# Service Bulletin

Bulletin No.: 18-NA-383

**Subject: Water Found in Rear Interior of Cab, Water Leak at Rear Sliding Window**

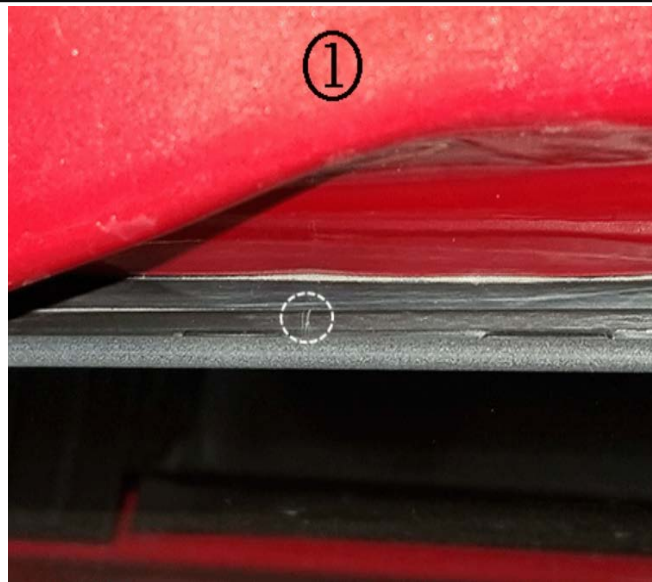
**Note:** The cracks can be in the left and/or right side of the rear sliding window plastic upper rail glass guide which is covered by the roof rear spoiler. Examples of a left (1), then right side (2) visual crack (with the spoiler removed) are shown in the graphics above.

The cause of the condition may be cracking in the rear sliding window plastic upper rail glass guide. The plastic upper rail glass guide may develop small fractures/cracking which allows water to pass through on the glass side of the urethane that attaches to the vehicle body.

R & R the roof rear spoiler and apply seam sealer to the rear sliding window top encapsulate, following the steps in the Service Procedure below.

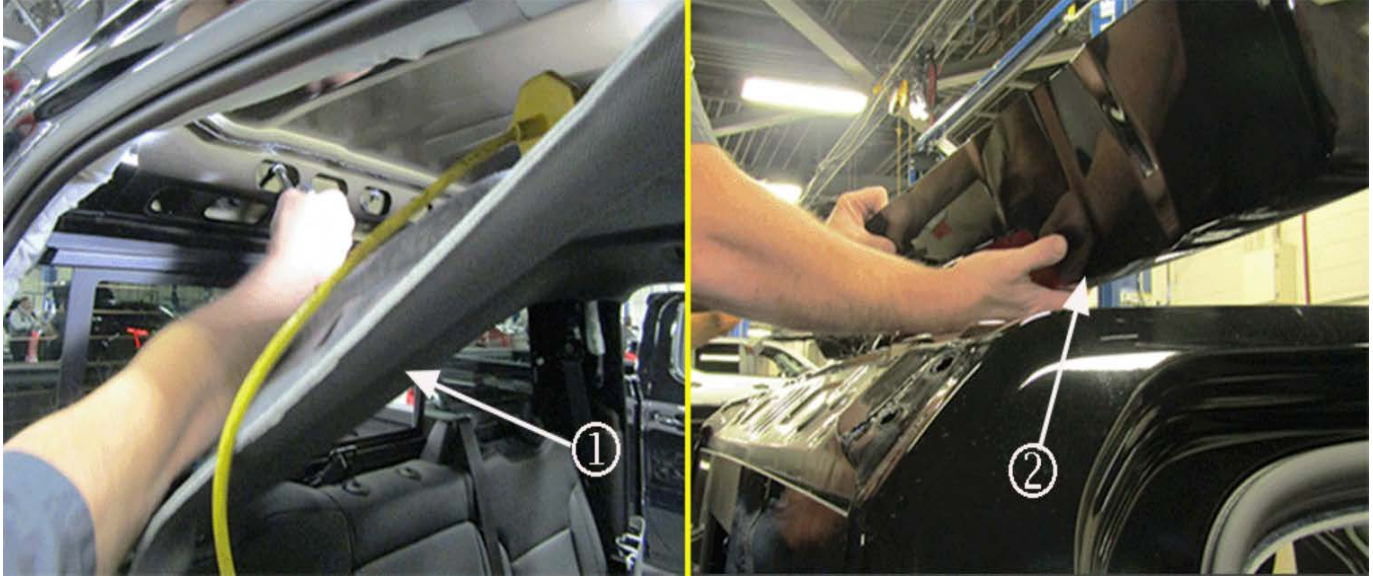
**Important:** When verifying this condition, ensure that the water leak path is due to cracks in the rear sliding window plastic upper rail glass guide, and NOT a leak in the primary urethane seal, between the window and the body; or from the spoiler attachments to the truck cab which are in the same area. Please indicate power sliding rear window crack in warranty claim verbiage.

**A leak in the primary urethane seal should be addressed by removing and resealing the window, using the standard service procedure from SI.**

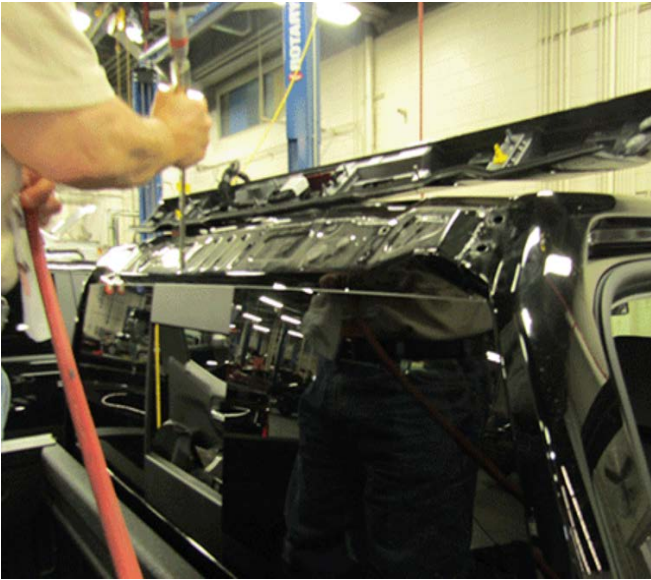
1. Lower the rear portion of the headliner (1) and remove the roof rear spoiler (2). Refer to *Roof Rear Spoiler Replacement*, in SI.
